## **Dock One Pty Ltd C/ Future Urban**

Convert the former Department of Marine and Harbours (DMH) Building into a motel, with car parking, and construct 10 overwater tourism suites and associated landings, moorings and floating access pontoons within the Port Adelaide River

040/L030/19

<b>Application No</b>	040/L030/19 (4234)
<b>Unique ID/KNET ID</b>	2019/06549/01
<b>Applicant</b>	Dock One Pty Ltd C/ Future Urban
<b>Proposal</b>	Convert the former Department of Marine and Harbours Building into a motel, with car parking, and construct 10 overwater tourism suites and associated landings, moorings and floating access pontoons within the Port Adelaide River
<b>Subject Land</b>	Lot 33 St Vincent Street, Port Adelaide Lot 213 & 601 Ocean Steamers Road, Port Adelaide Lot 700 (Port River), Port Adelaide
<b>Zone/Policy Area</b>	Regional Centre Zone / Dock One Policy Area
<b>Relevant Authority</b>	SCAP
<b>Lodgement Date</b>	30 May 2019
<b>Council</b>	Port Adelaide Enfield
<b>Development Plan</b>	Consolidated 06 February 2018
<b>Type of Development</b>	Merit
<b>Public Notification</b>	Category 2
<b>Representations</b>	Nil
<b>Referral Agencies</b>	DPTI (Transport), Government Architect, C

**Figure 8 – Proposed Off-Street Parking adjacent Wauwa Street**

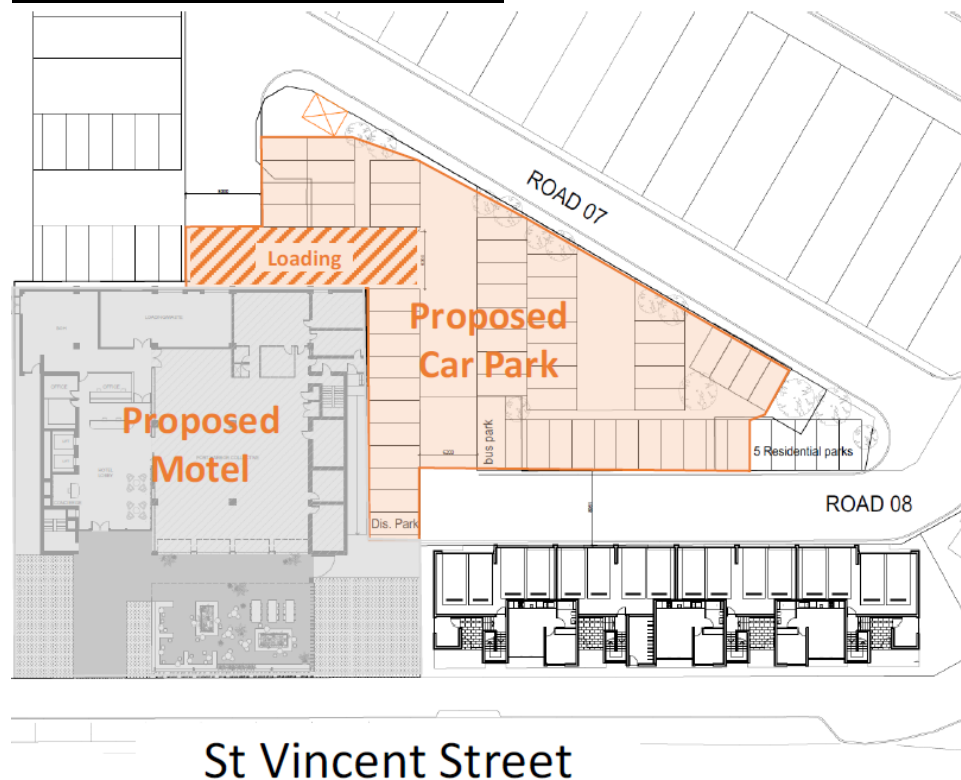
Council has requested clarity in relation to traffic matters for this stage of development. These matters, along with the applicant's response, are summarised below and further discussed below where necessary.

<b>Council Comment</b>	<b>Applicant's Response</b>
Stacked/tandem parking to the north-west of the motel site car park is less than ideal and only work for valet.	All the stacked car parks will be used by the motel as valet parking.
GTA's comparison with suburban Melbourne motel are unlikely to be a true comparison for Port Adelaide.	Council has not produced any specialist or technical advice to support its assertion.
Vehicles directly reversing out of proposed car parks abutting Road 07.	The layout of this car park has been reviewed and endorsed by GTA traffic engineers.
Location of disability space to motel entrance and without a shared space adjacent.	The car parking space is adjoined on its southern side by a shared area and the ramp on the eastern side of the motel complies with the National Construction Code.
Concern over new serving arrangements for a Council waste truck via the motel car park.	A right of way in favour of the Council is to be established to allow for waste collection to occur over privately owned land.

While Council has raised concern with GTA's comparison (with suburban Melbourne motels), 'Tourist Accommodation' under *Table PAdE/5A Off-Street Parking* is specifically excluded and therefore no max/min rate is prescribed by the Development Plan and the evidence from GTA in regards to anticipated demand for a motel in this location is considered sound and reasonable.

**Figure 9 – Turn path for heavy vehicle**

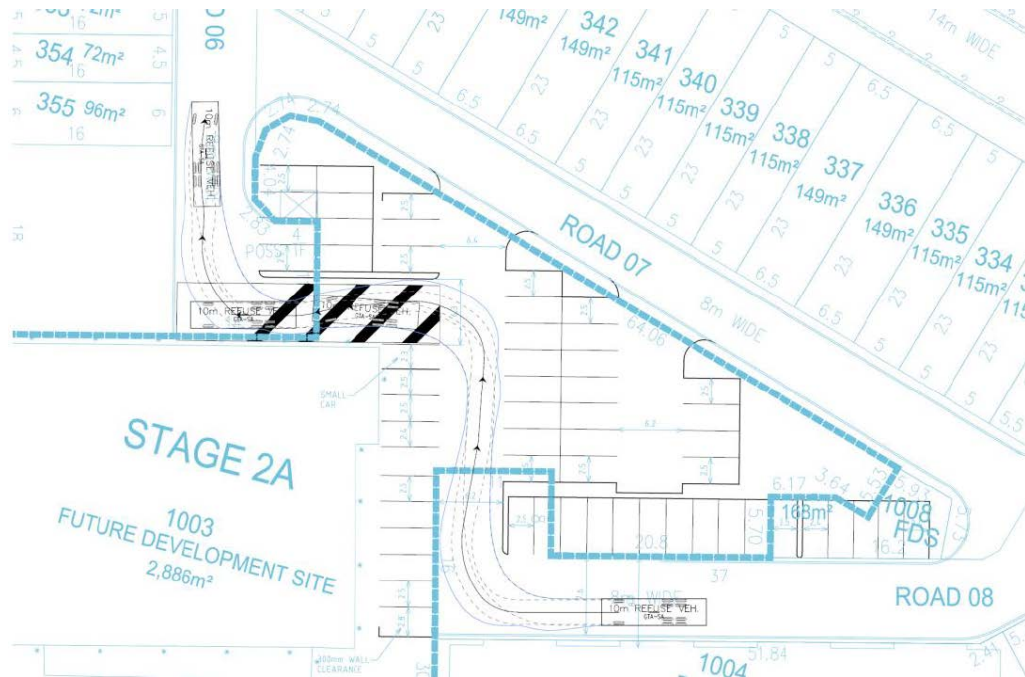
Given all the above changes and comments, can GTA provide an updated parking plan for the Motel and Stage 2 with new road layouts and demonstrate the swept paths for delivery and garbage truck and mini bus access to Motel and adjacent dwellings.

This dock has been designed to cater for these vehicles to enter, park and exit in a forward direction as shown below in Figure 6. It is anticipated that waste collection would occur weekly and linen/food/beverage services would occur between 3-4 times per week.

**Figure 11– Location of Existing and Proposed Overwater Structures**

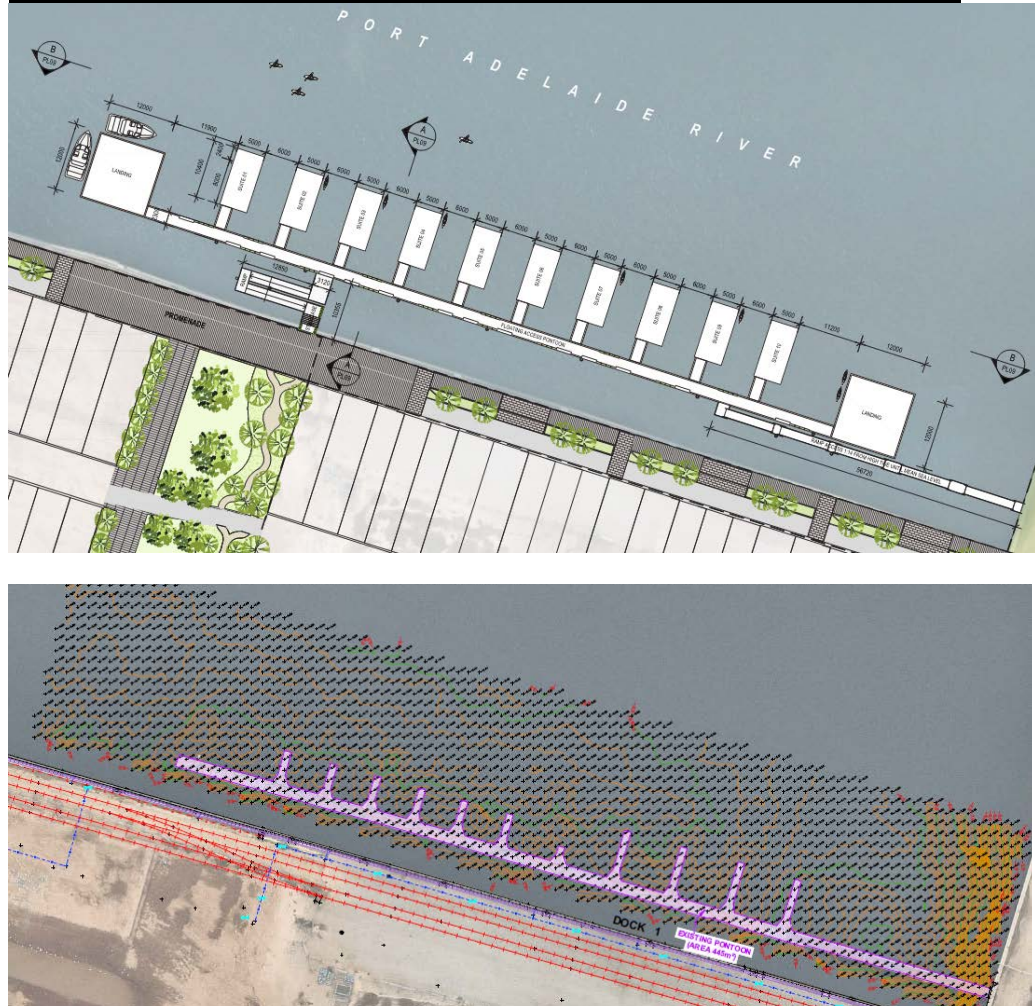
Given the location of the development (both the motel and over water suits in relation to the Port River), the application was formally referred to the Coastal Protection Board (CPB) and the applicant was requested to provide further details (by the CPB, Council, the GA and SCAP Administration) regarding the existing/proposed structures in the Port River to allow for construction of the overwater development and associated infrastructure. Specifically, the following information was requested by **SCAP**:

- *A scaled plan showing the location of the structures in the Port River to be removed/demolished (including the landings, pontoons, moorings and piles) and the location of the new structures proposed (i.e. piles).*

- *If piles are removed, please provide information regarding the likelihood of mobilising sediment contaminants by a qualified professional assessing sediment quality with the resultant report providing an assessment of the sediment quality and levels of contaminants (including: Tributyltin, copper, lead, zinc, PFAS, sediment size, pH and hydrocarbons). If contaminant levels exceed sediment quality guidelines then please describe how this will be managed to avoid environmental harm.*

- *A deconstruction plan with detail of how the works will be done, what water quality monitoring will be undertaken, and how any pollution liberated from the sediment as part of the deconstruction process will be managed e.g. monitoring during deconstruction must include at a minimum turbidity/total suspended solids, dissolved oxygen and pH.*

In response to the above, the applicant has not confirmed what is to be specifically demolished/removed and the associated management of this to demonstrate coastal protection. In the applicant's opinion, *'...the department does not need to know about the methods that are proposed to dismantle and remove the exiting overwater structures for two reasons. First, development plan consent is not required to dismantle or remove the existing overwater structures. Second, a separate development application for building rules consent and development approval will be lodged by the Applicant to lawfully dismantle and remove the existing overwater structures'*. In regards to waste/grey water, the applicant has also outlined *'All grey/water is to be removed via a pipe connected to the sewer'*.

Notwithstanding the applicant's response above, 'demolition' of these existing structures in the Port River is not considered exempt from requiring Development Plan Consent (DPC) pursuant to Schedule 3 of the *Development Regulations 2008*. Given a formal referral under Schedule 8 was required to the CPB, 'demolition' in this case is assessed on its 'merits' and cannot be exempt from requiring DPC. Furthermore, while the lodgement of building rules consent may assess the removal of structures under the Building Code of Australia, it does not outline and govern the management and measures needed to ensure appropriate coastal protection within the Port River (identified as a wetland of national importance and covered by the *Adelaide Dolphin Sanctuary Act 2005*). While the
